ADMINISTRATIVE DESIGN REVIEW - RESPONSE

ADMINISTRATIVE DESIGN REVIEW RESPONSE
ADR 3034692
2335 Boylston Ave E
Seattle, WA 98102

PROJECT DESCRIPTION:
6-story congregate residence with 72 sleeping rooms. Existing buildings to be demo'd. No parking proposed.

ADMINISTRATIVE EARLY DESIGN GUIDANCE
October 13, 2020

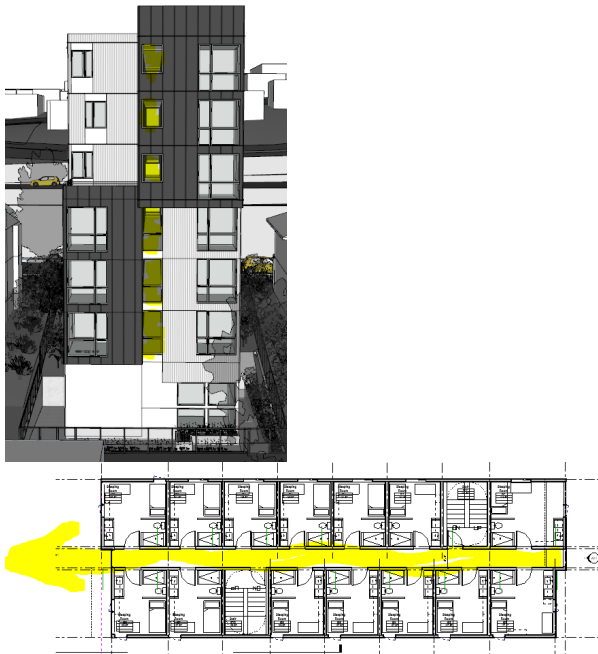
- b. Staff is less supportive of the southeast, upper level, carved area along Boylston Ave, which is designated as a private balcony space overlooking the I-5 corridor and suggests that the design work on ways to design the space to be more equitable. **(DC2-B, DC2-C-1, DC2-C-2)**

The SE corner is no longer a deck. The NW corner deck provides a better opportunity for a successful outdoor space because of views and solar exposure. While the SE facing deck overlooks I-5 it is a less desirable deck location.

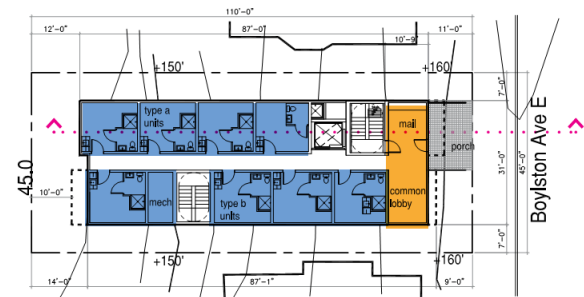
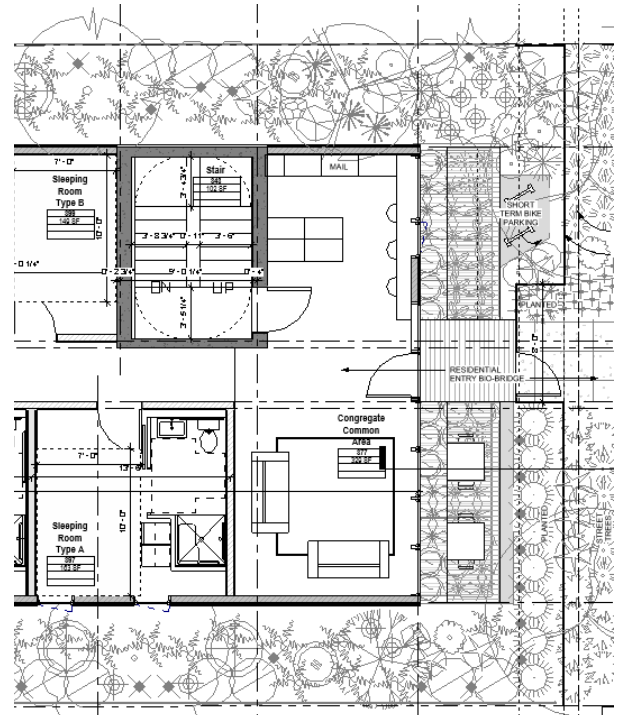
- d. Staff supports the recessed northeast corner of the building, designed to accommodate the double floor height building entry. However, Staff is concerned that the size of the entry transition and lobby are less than adequate. (CS2-A-1, CS2-A-2)

RESPONSE:
To expand the entry transition, the project proposes to expand the front porch shown at ADR across the entire building frontage. This porch is a soft hardscape, and uses a decking surface suspended over planting. A solid 'bridge' crosses the landscape at the building entry.

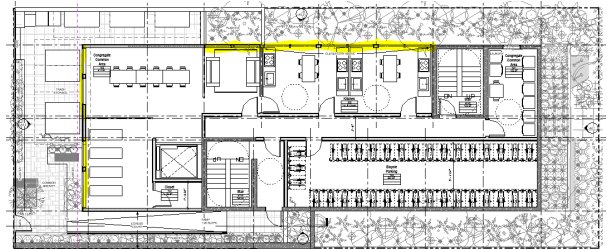
a. Staff supports the overall architectural concept which emphasizes strong rectilinear forms and secondary architectural elements designed to reduce the perceived mass of the building. (DC2-A-02, DC2-B-1, DC2-C-1)

RESPONSE: Proposed massing further emphasizes the stacked rectilinear masses and secondary architectural elements to reduce the perceived mass of the building.

North Facade

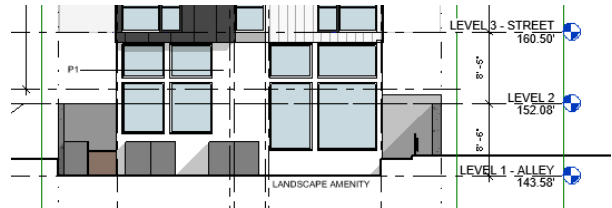
c. Staff is not in support of and is concerned with the programming of the building which relies on private balconies overlooking the highway, below ground amenity spaces with no windows and a reported congregate living

facility that does not have a common kitchen per floor. (CS2-C-2, DC3-B-4)

RESPONSE: The project team agreed that the balconies overlooking the high-way were not desirable and this has been eliminated. Because of the steep topography, the amenity spaces are day lit and at grade at the alley side. The interior common spaces are able to provide high ceilings and clerestory windows to allow in additional daylight, as well as windows providing views to the West and North onto amenity space and planting.

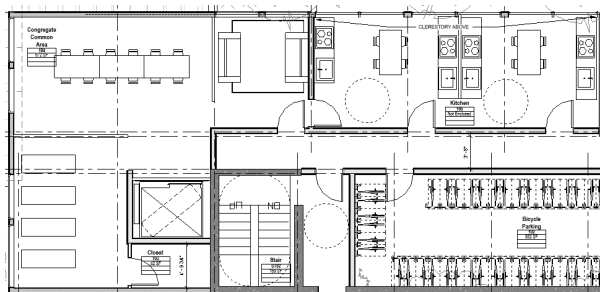
d. Staff is not in support of the notched corners being targeted as private amenity space in a congregate living facility while relegating the congregate common space to the lower alley level which has no windows or view. Staff could be in support of the open space design if the notches were used for congregate common space which would be more equitable. (CS2-C-2, DC2-B-1, DC2-C-1)

RESPONSE: To provide a more equitable use, the rear notch is proposed as common amenity space. Note that the NW deck does not meet the dimensional requirements for a common amenity space and the project will ask for an additional departure for a reduction in required amenity space.

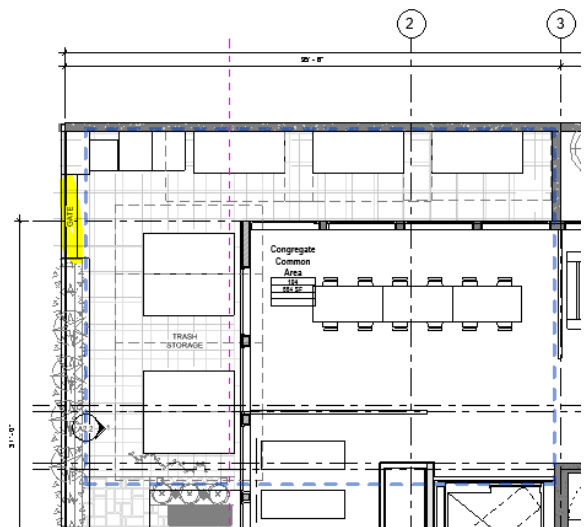
- b. The Design Guidelines call for appropriate high-quality materials which should have sufficient thickness to prevent warping and deformation. **(CS3, DC4-A1, DC4-A2)**

RESPONSE: High quality materials are important to this project both in terms of aesthetic presence and creating an elegant building, but also in terms of maintenance and durability, considering the location.

White siding is a box-rib metal siding that will provide significant relief and depth. The dark mass is a fiber cement panel that is cut into vertical strips with pronounced flashing profiles. This profile detail allows the fiber cement to appear like a standing seam metal. Fiber cement is chosen, instead of metal for instance, to allow for a better selection of colors. Rather than the colder colors available in metal siding, this project will use a warm gray color.
